STAFF REPORT
COMMUNITY DEVELOPMENT DEPARTMENT

HEARING DATE: 7/21/2020
 TO: Mayor & City Council
 FROM: Alan Tiefenbach, Associate Planner
 208-489-0573
 Bruce Freckleton, Development Services Manager
 208-887-2211
 SUBJECT: H-2020-0032
 Brody Square

Annexation & zoning of 15 acres of land (3 different properties) with an R-8 zoning district, and preliminary plat consisting of 65 building lots and 7 common lots, by Pinnacle Land Development, LLC. This request also includes vacating approximately 275 feet of Daphine Street.

A. Preliminary Plat (date: 7/1/2020)

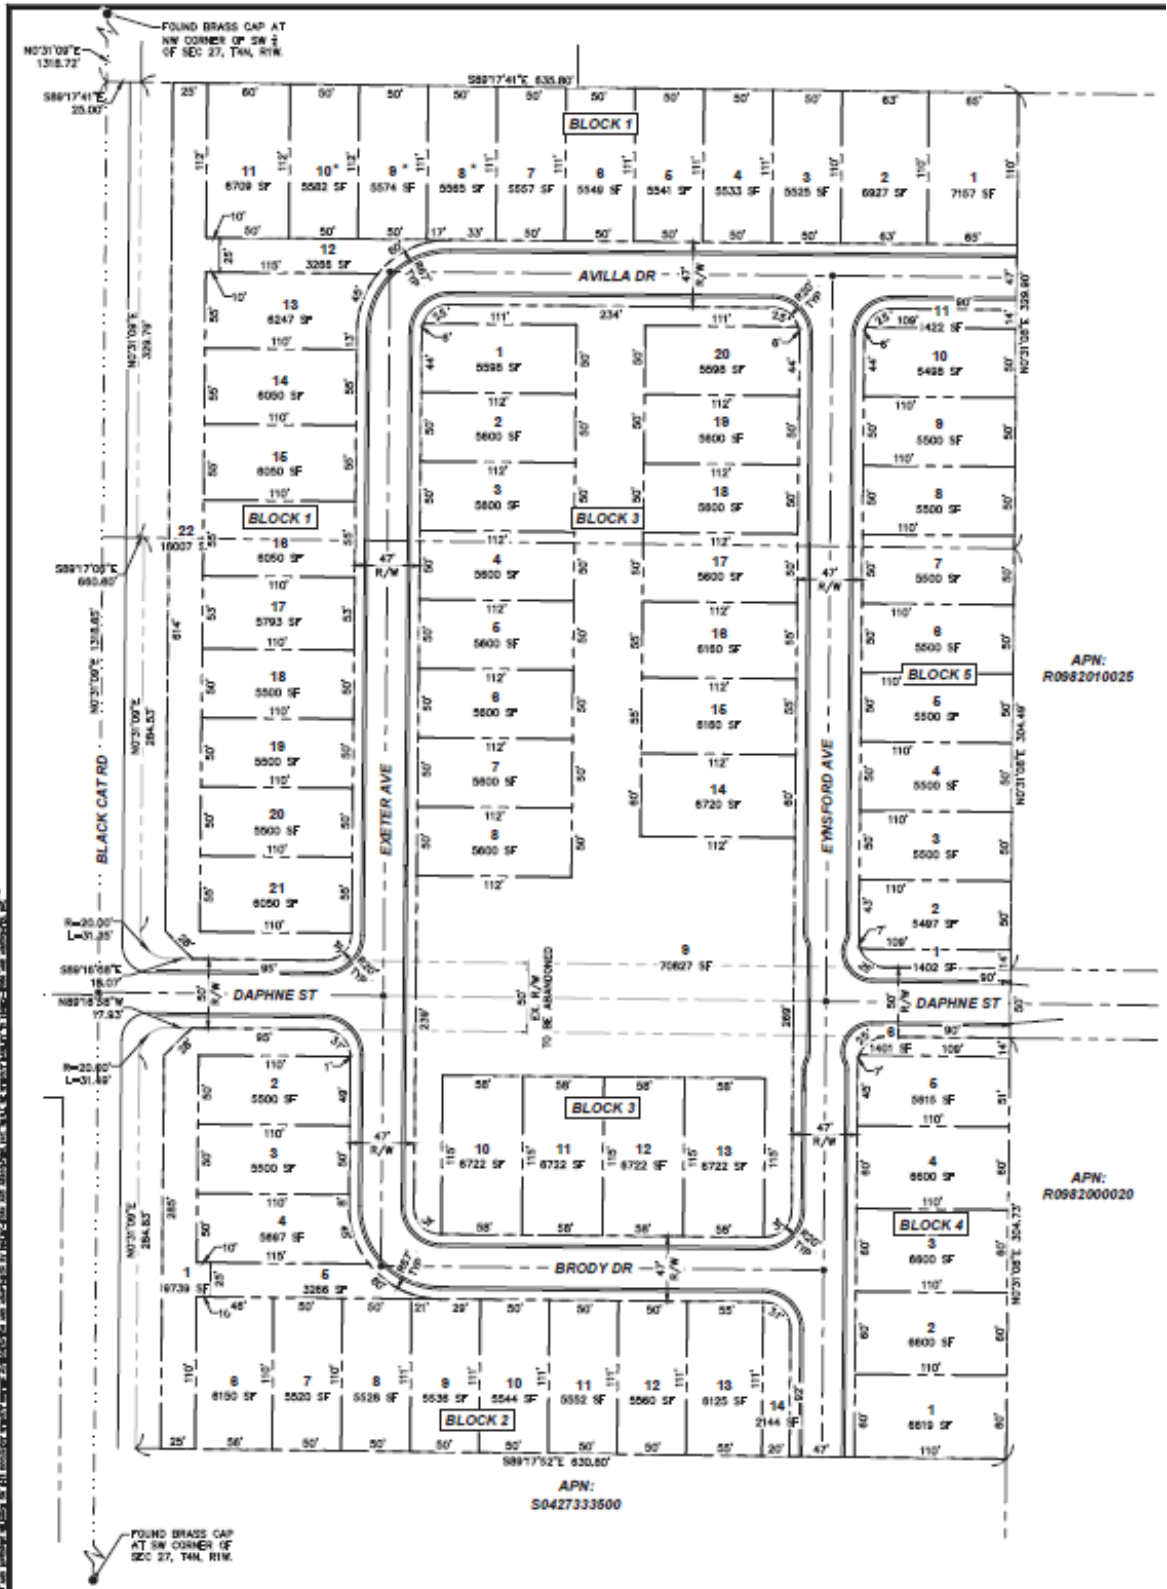
The central park amenity shown in Lot 9 consists of a small pond, a gazebo and several pathways. At present, the pond cuts off walkway access in the middle of Block 3. It is staff’s opinion that connecting the two pathways along the pond would result in more useable space. Staff has added this as a recommended condition of approval.

During the November 7, 2019 Pre-Application Meeting, staff recommended that a stub street should be provided to the north from Avilla Drive through Block 1. This is to allow future access from the property at 5230 N. Black Cat Rd if it were to redevelop in the future. This access is not provided. Staff is recommending this as a condition of approval.

- a. Remove staff condition for a stub street to be provided to the north from Avilla Drive through Block 1.
 - b. Remove Lot 61 to reconfigure the pond into this area to provide a better open space and allow the connection of the pathways as recommended by staff.

5. Outstanding issues(s) for City Council:
- a. The lot numbering on the plat versus the landscape plan is not consistent. The plat has the correct numbering. The Planning Commission recommendation for homes on Lots 42-44 to be limited to one-story should be changed to Lots 8-10, Block 1.

2. This approval is based upon ACHD vacating the requested section of Daphne St.
 3. The plat included in Section VII, dated 7/1/2020, shall be revised as follows prior to submittal of the final plat application:

- i. ~~A stub street shall be provided to the north from Avilla Drive through Block 1. This is to allow future access from the property at 5230 N. Black Cat Rd if it were to redevelop in the future.~~

B. Landscape Plan (date: 7/1/2020)

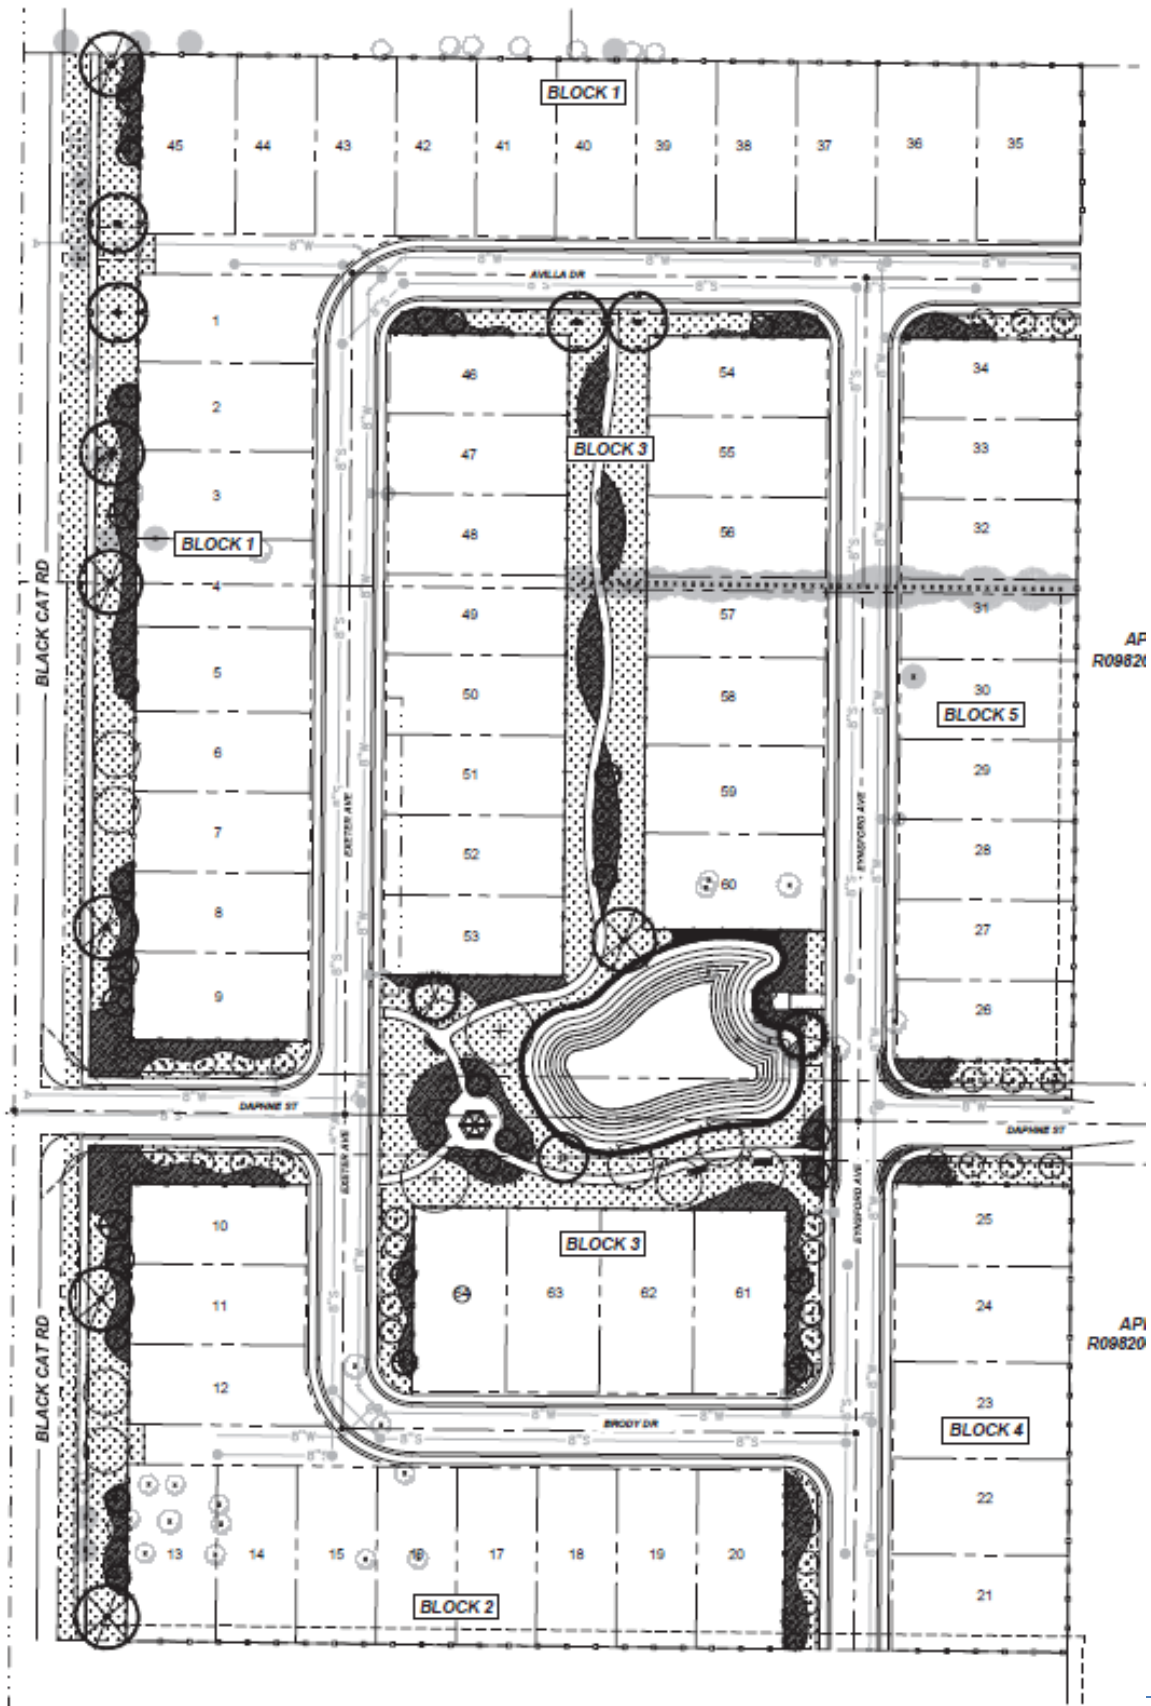
The applicant is requesting an open water pond be credited toward their qualifying open space (as is discussed below). For full credit, staff recommends the northern and southern pathways connect along the pond to produce a more inviting and useable area.

All fencing is required to comply with the standards listed in UDC 11-3A-6C and 11-3A-7. Fencing is shown on the landscape plan and consists of 6' high solid vinyl fencing around the entire perimeter of the development (including along Black Cat Road, and 5' open style lattice top fencing along the common areas. *There are several areas within Lot 9 (the common area) where closed style fencing is shown. UDC 11-3A-7 requires any fencing abutting pathways and open space to be open style.*

4. The landscape plan included in Section VII.C, dated ~~2/2/2020~~ 7/1/2020, shall be revised as follows prior to submittal of the final plat application:

- a. ~~The northern and southern pathways shall connect at the pond to result in a continuous pathway along the pond.~~
 - b. ~~Sitting and passive recreation areas shall be depicted on the landscape plan.~~

- c. The fencing shown in Block 3 shall be revised to be open style as required per UDC 11-3A-7.
 5. The applicant will submit a tree mitigation plan at time of final plat. This mitigation plan shall indicate the total number and caliper inches of trees proposed for removal and the total number of replacement trees proposed.
